24 February 2010

Your reference: DA 2010/0286

**PROPOSED BULKY GOODS RETAIL, FAST FOOD OUTLETS, SERVICE
STATION & FIVE LOT SUBDIVISION
1 PAT O'LEARY DRIVE, KELSO**

TITLE
SITE PLAN - LAYOUT

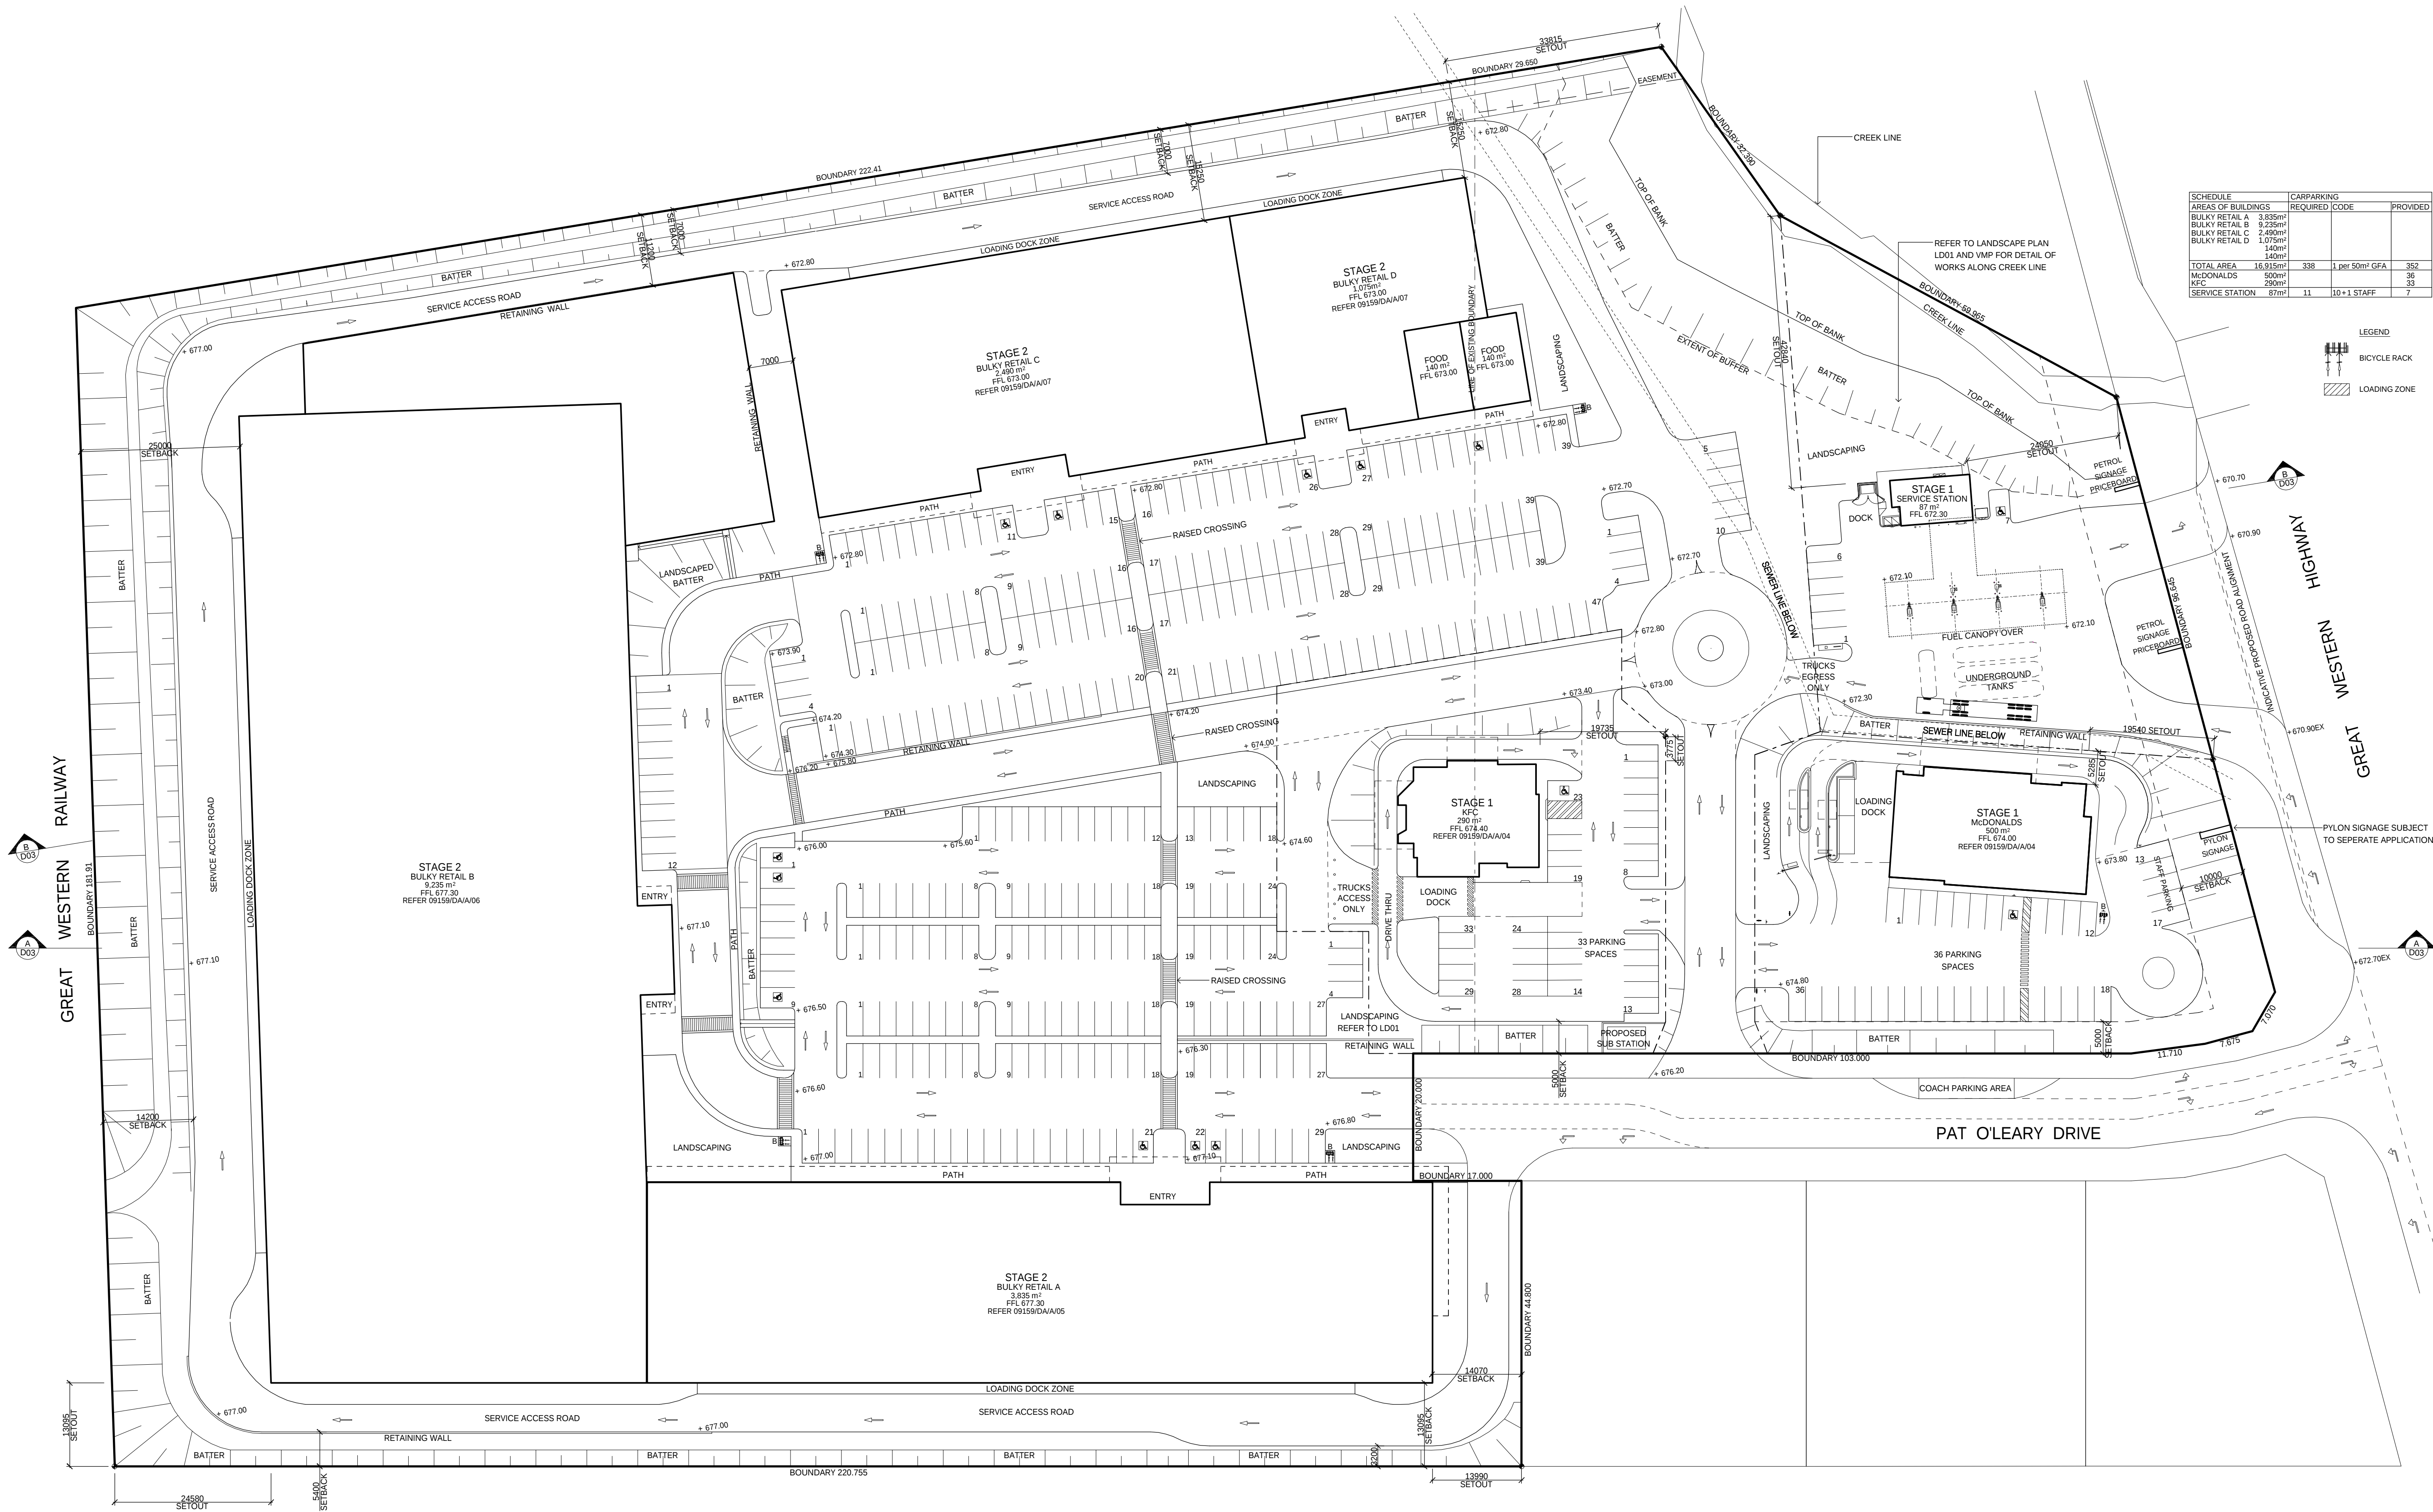
- *The RTA will require acquisition of some land for the above highway upgrading; this could be up to 6m from the highway frontage. In addition to Councils' requirement for a 10m building setback, the total setback would be 16m.*

- *The RTA may require land for the highway upgrade precinct on the north eastern side of Lot 5 DP 838537 adjacent to Lot 2 DP 838537; this will require a 20m setback from the property boundary near the proposed bulky goods.*

4. *The number of parking bays shown on Drawing No. 09159/DA/A/02 Revision A is less than the number stated in the traffic report.*

The site plans have been amended to ensure that a total setback of 16m is provided.

The site plans have been amended to provide a 20m setback as required.

The amended traffic report and architectural plans are now consistent in terms of the proposed parking provision.

APPENDIX 5

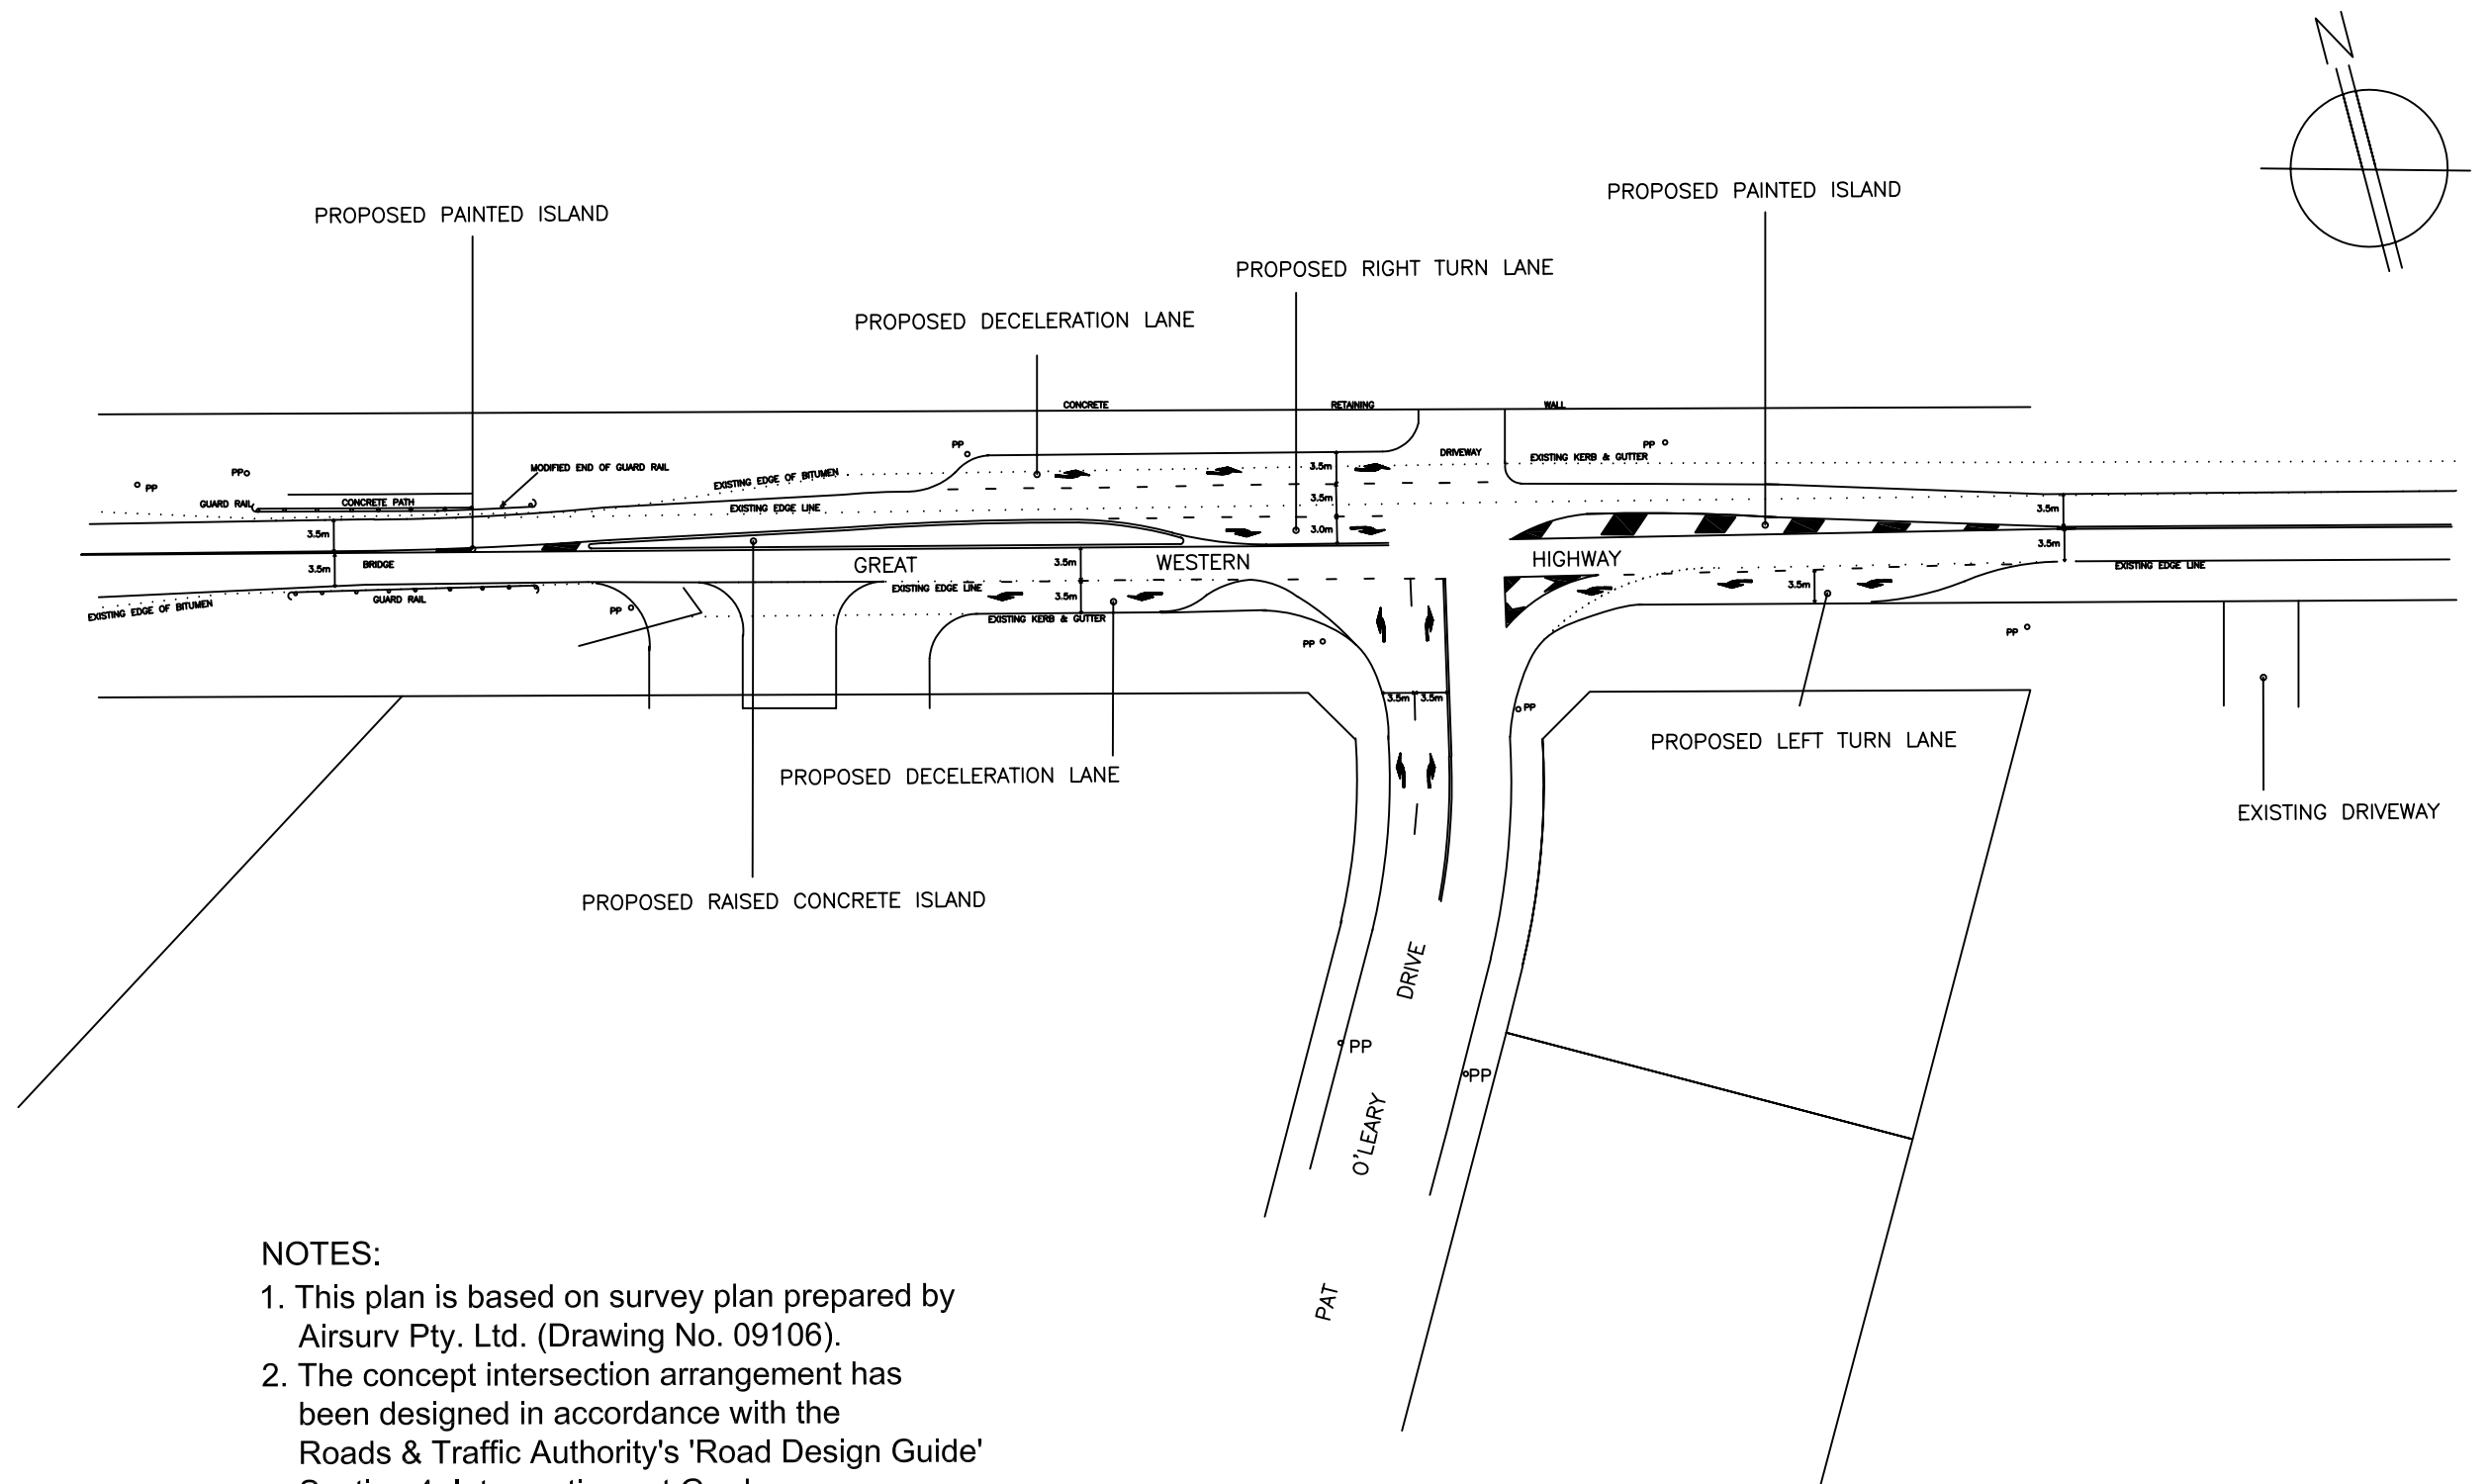
- *The length of the left turn lane from the Great Western Highway into the service station in the proposed form is not acceptable to the RTA. There are safety concerns with the proximity of Pat O'Leary Drive to the proposed service station access. It is undesirable to have traffic entering and exiting the highway so close to the intersection of Pat O'Leary Drive, particularly considering that the intersections may be signalised in the future.*

- *The developer is to provide details to the RTA of the proposed intersection treatment with the Great Western Highway to cater for traffic from Stage 2 of the development, including pavement widening.*

The length of the left turn lane from the Great Western Highway into the service station has been increased from 30m to 40m, an increase of 33%. Table 4.8.3 of the RTA's Road Design Guide specifies that a vehicle is able to decelerate from 60km/h to 0km/h over such a distance (40m) incorporating a desirable maximum deceleration rate of 3.5m/s². Vehicles are therefore projected to be capable accessing the service station via the proposed deceleration lane without the need to commence decelerating within the adjoining through Great Western Highway traffic lane.

The traffic study indicates that traffic signals will be required to adequately accommodate the additional traffic projected to be generated by the stage 2 development. The provision of traffic signals will only require minor alterations to the Stage 1 junction upgrade treatment including the provision of signalised pedestrian crossings, the deletion of the pedestrian refuge, the provision traffic signal posts and lanterns and detector loops. A concept junction upgrade plan has been prepared by this Practice and is attached to this correspondence for review.
